**STAGE 1
ROAD SAFETY AUDIT RESPONSE**

LAND WEST OF GATESMEAD

Project Name: Land West of Gatesmead
Project Ref: 5029426
Prepared by: Ridge & Partners LLP
On Behalf of: Crest Nicholson Operations Ltd
Report Title: Stage 1 Road Safety Audit Response
Date: April 2026
Document Ref: 5029426 – Land West of Gatesmead - S1RSA Response

DRAWING No: 5029426-RDG-XX-XX-DR-H-PL001-P04.dwg

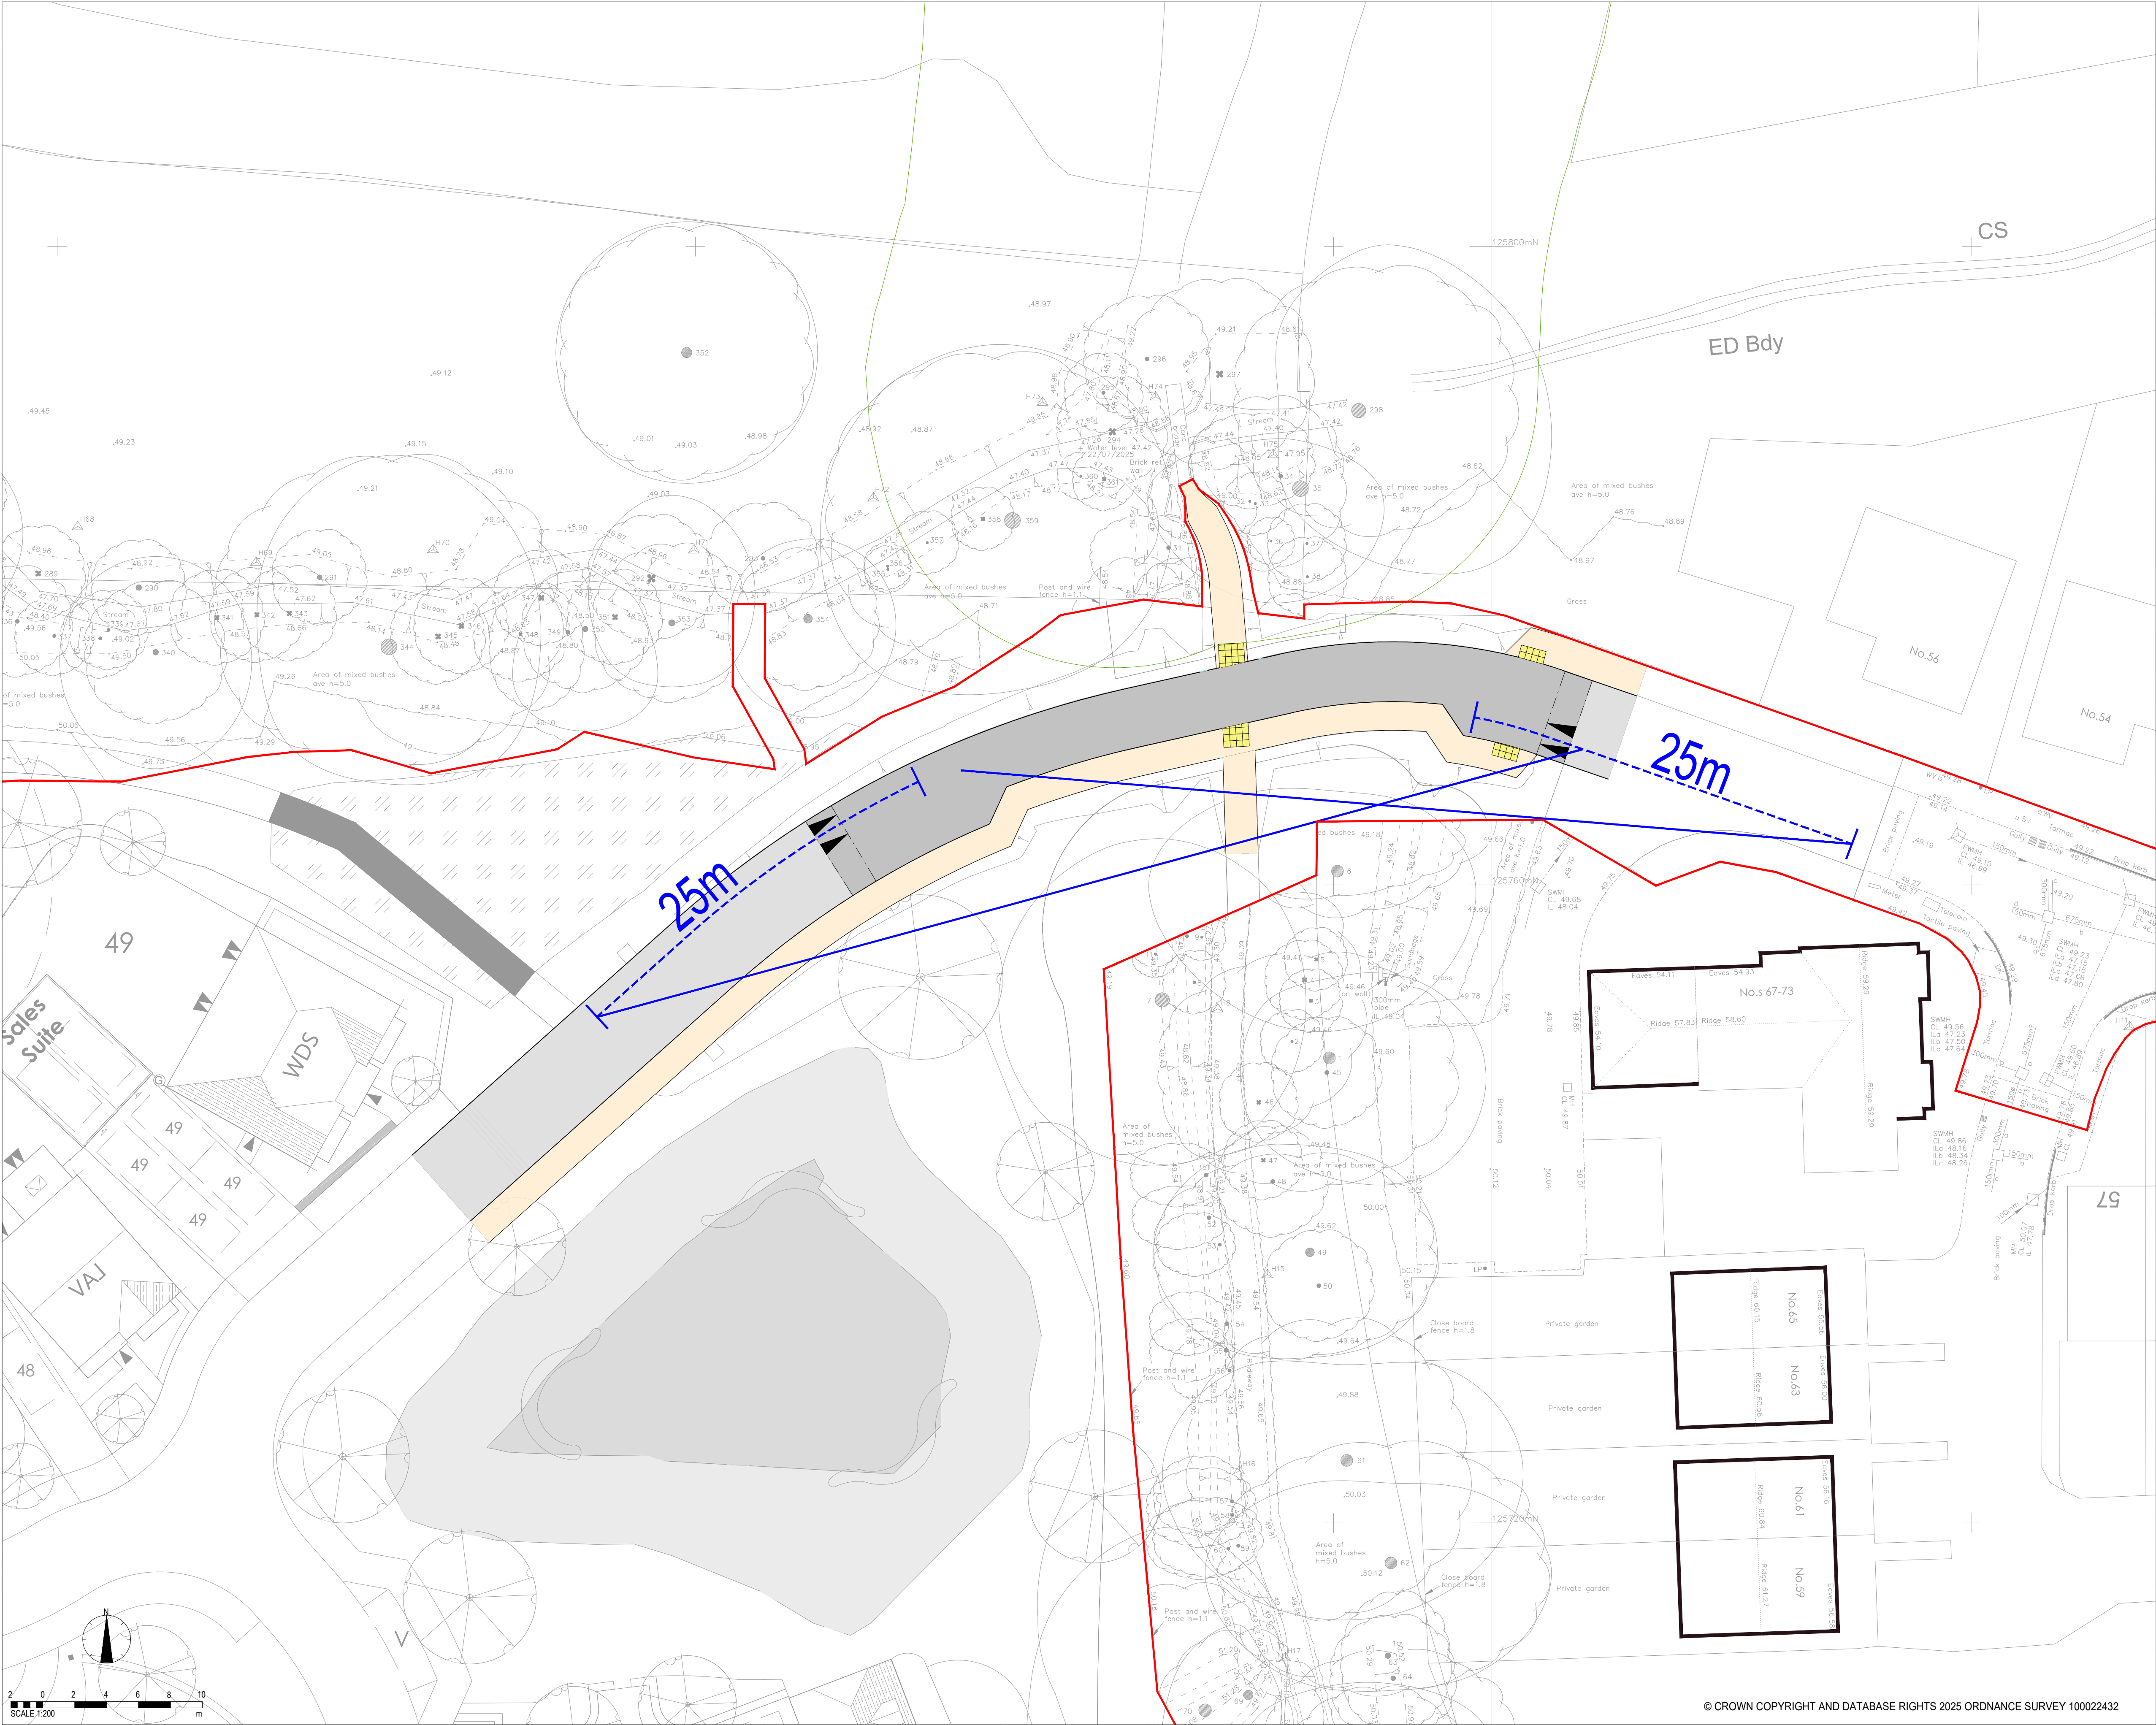
RSA PROBLEM	RSA RECOMMENDATION	DESIGN ORGANISATION RESPONSE	OVERSEEING ORGANISATION RESPONSE	AGREED RSA ACTION
Problem 8.3 <u>Location:</u> Gatesmead. Vehicles approaching from the east <u>Summary:</u> Forward visibility splay as detailed for vehicles approaching from the east appears to extend across private land with hedge outside plots 67-73 There is a visibility splay detailed for vehicles approaching from the east that encroaches across private land with a hedge. This will obstruct the visibility splay as detailed. Amend vis splay so it does not extend over private land. 	Amend vis splay so it does not extend over private land.	The visibility splay for vehicles approaching from the east extends across land and boundary treatment that is under the control of Crest Nicholson. The existing hedge outside plots 67–73 will be retained or removed as necessary at the detailed design stage. The identified land is under the control of Crest Nicholson and therefore ongoing management can be secured, no amendment to the visibility splay is considered necessary.

8.3*Problem* (Item A2.1)	
Location:	Gatesmead . Vehicles approaching from the east
Summary:	Forward visibility splay as detailed for vehicles approaching from the east appears to extend across private land with hedge outside plots 67-73
  There is a visibility splay detailed for vehicles approaching from the east that encroaches across private land with a hedge. This will obstruct the visibility splay as detailed. Amend vis splay so it does not extend over private land	
TYPE OF CONFLICT/COLLISION	
Risk of vehicle collisions due to reduced forward visibility	
RECOMMENDATION	
Amend vis splay so it does not extend over private land

P04	Updated following comment	15/04/2026	RC	SM
P03	Update Layout	08/04/2026	RC	SM
P02	Update Layout	30/03/2026	RC	SM
P01	First issue	25/03/2026	RC	SM
REV	DESCRIPTION	DATE	BY	CHKD
ORIGINATOR:	www.ridge.co.uk

DRAWN BY:	RC	CHECKED BY:	SM	APPROVED BY:	SM
SCALE @ A1:	1:200	DATE OF REVIEW:	08/04/2026		
ISO 19650 STATUS:					
FOR PLANNING					
DRAWING No:	5029426-RDG-XX-XX-DR-H-PL005-P02.dwg				
PROJECT:	ORG:	FUNCTION:	SPATIAL:	FORM:	DISCIPLINE:
5029426	RDG	XX	XX	DR	H
				PL005	P02

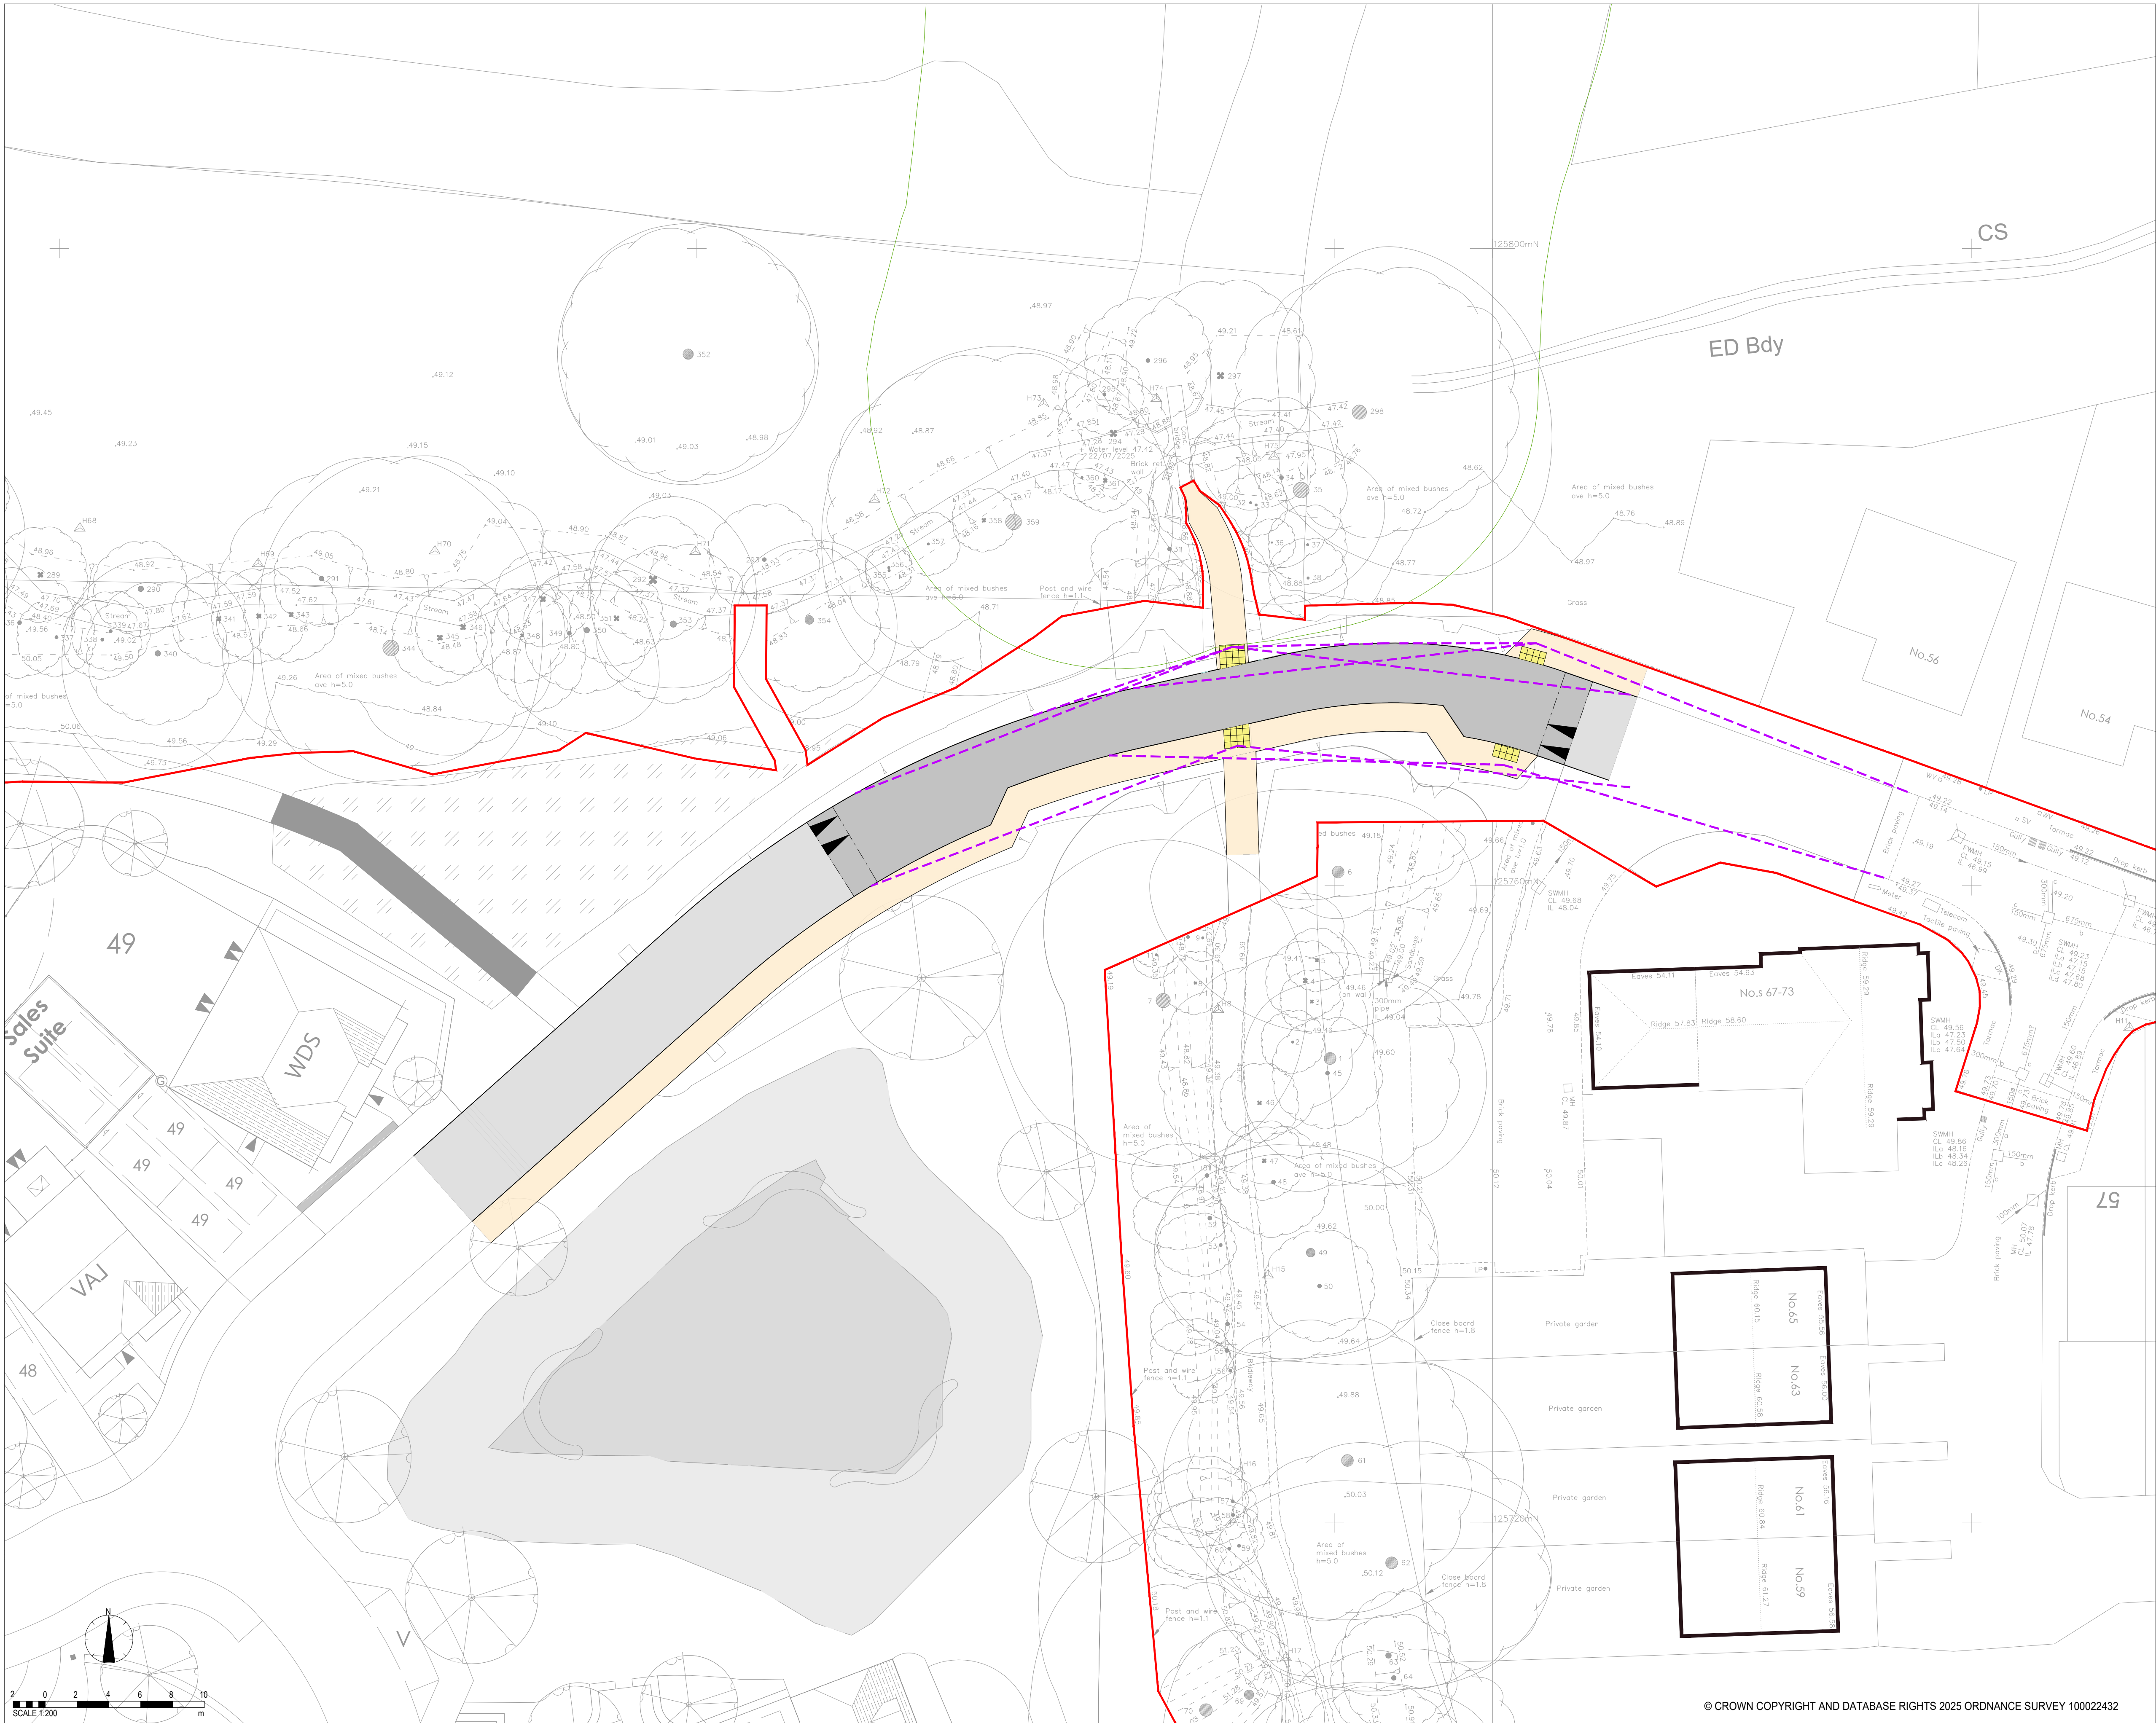
Problem 8.2 <u>Location:</u> Proposed narrowing on inside of bend. <u>Summary:</u> No visibility splays detailed to show vehicles approaching narrowing can see opposing vehicles approaching narrowing around inside of bend in both directions. There are no visibility splays detailed to show vehicles approaching the narrowing on the bend can see opposing vehicles in the opposite direction in both directions. Drivers need to see vehicles approaching in the opposite direction in advance of the narrowing so they can decide to stop and wait before proceeding to prevent a head on collision. Provide appropriate forward visibility splays where required over adopted land. 	Provide appropriate forward visibility splays where required over adopted land through narrowing and around bend.	The blue visibility splay line shows that a vehicle approaching west-bound at 20mph (assuming a priority sign is installed east-bound similar to the existing build-out to the east) can see a car approaching east-bound within Manual for Streets (MfS) stopping sight distance (SSD) for 20 mph (25m) . Drawing 5029426-RDG-XX-XX-DR-H-PL005-P02 has been prepared to show forward visibility splays to the proposed carriageway narrowing in both directions to allow approaching drivers to see opposing vehicles MfS SSD for 20mph (25m) in advance of the narrowing. These have been designed to provide appropriate visibility around the inside of the bend. This demonstrates that priority may not be required. This can be decided at detailed design stage.

8.2*Problem* (Item A2.1)	
Location:	Proposed narrowing on inside of bend
Summary:	No visibility splays detailed to show vehicles approaching narrowing can see opposing vehicles approaching narrowing around inside of bend in both directions.
 There are no visibility splays detailed to show vehicles approaching the narrowing on the bend can see opposing vehicles in the opposite direction in both directions . Drivers need to see vehicles approaching in the opposite direction in advance of the narrowing so they can decide to stop and wait before proceeding to prevent a head on collision. Provide appropriate forward visibility splays where required over adopted land	
TYPE OF CONFLICT/COLLISION	
Risk of head on collisions due to reduced forward visibility on approaches and through narrowing on bend	
RECOMMENDATION	
Provide appropriate forward visibility splays where required over adopted land through narrowing and around bend

- KEY
- APPLICATION BOUNDARY
 - PROPOSED TACTILE PAVING
 - VISIBILITY TO SEE VEHICLE ON NARROWING 25m IN ADVANCE OF STOPPING POSITION. 25m SSD AT 20mph MANUAL FOR STREETS
